# PARTS & SERVICE NEWS

REF NO.	AT04021
DATE	Feb. 25, 2004
(C)	Page 1 of 3

**SUBJECT:** REPLACEMENT OF NAME PLATE OF ROPS CAB ON GD555-3C, 3A  
GD655-3C, 3A, GD675-3A

**PURPOSE:** To introduce replacement procedure of the name plate of the ROPS cab on GD555-3A/3C, GD655-3A/3C and GD675-3A/3C motor graders

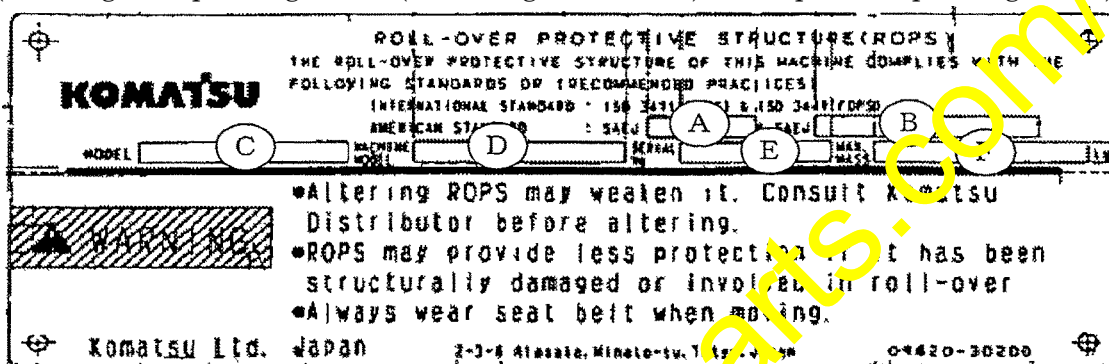
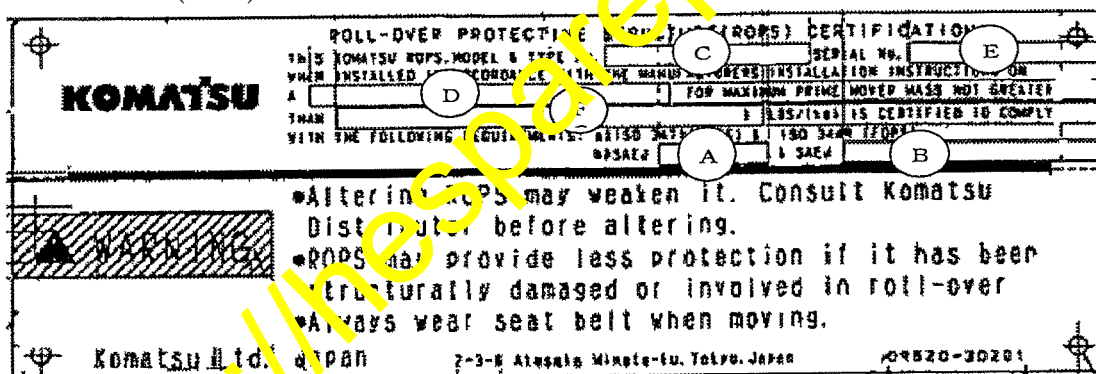
Since there were errors found in the weight indication stamping on the name plate of the ROPS cab being attached to the GD555-3A/3C, GD655-3A/3C and GD675-3A/3C motor graders which have been shipped out, replace the name plate with the new plate being sent to you directly from our plant.

- Descriptions of the new name plate are as follows.
- The weight indications on the Item ⑥ have been corrected as seen in the Table shown below.
- The Production No. of the ROPS cab is not stamped on the new name plate. Stamp the same Production No. as stamped on the column ⑥ of the current name plate on the column ⑥ of the new name plate before attaching it to the machine. (Refer to the next page regarding the stamping procedure.)

ItemNo.	①	②	③		④	⑤	⑥	
			Low rops	High rops			09620-30201	09620-30200 09620-10200
Current	-	1040MAY94	6GB45	6GB41	GD655-3 or GD670-3	Production No. of each ROPS cab (4 figures)	41225(18700)	18700
New	No correction (Same stampings as on the current name plate are stamped.)					*No stamping (Blank)	Corrected ↓ 47180(21400)	Corrected ↓ 21400

## (2) Replacement work procedure

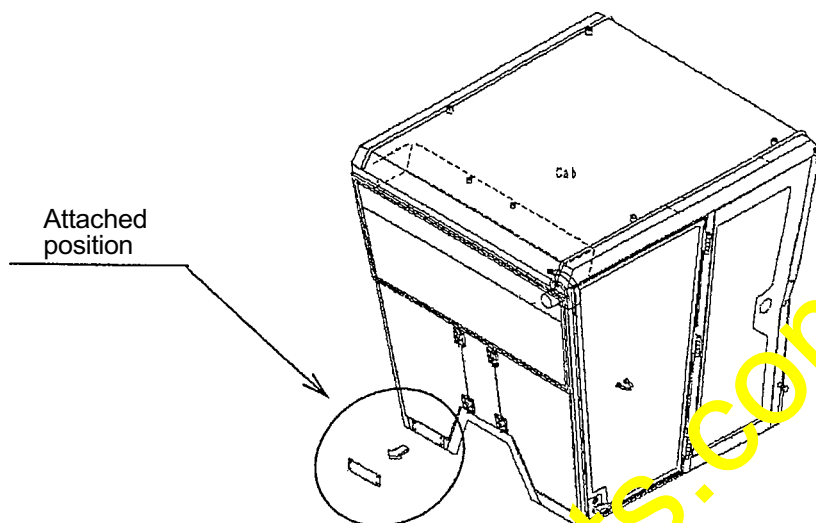
※ Remove the current name plate attached to the ROPS cab.

- Since the column ⑤ of the new name plate is in blank, be sure to stamp the same Serial No. as the one stamped on the current name plate.
- The position to stamp the Production No. (Serial No.) is on the column ⑤ per the Section (1) "Details of the corrections".
- Stamping letter size: Stamp the number at the size of 3.2 mm.

※ Attach the new name plate on which stamping of the Serial No. has been made as per the above Process 2) on the ROPS cab.  
Use 4 pcs. of the screws (04418-13060) to attach the name plate.
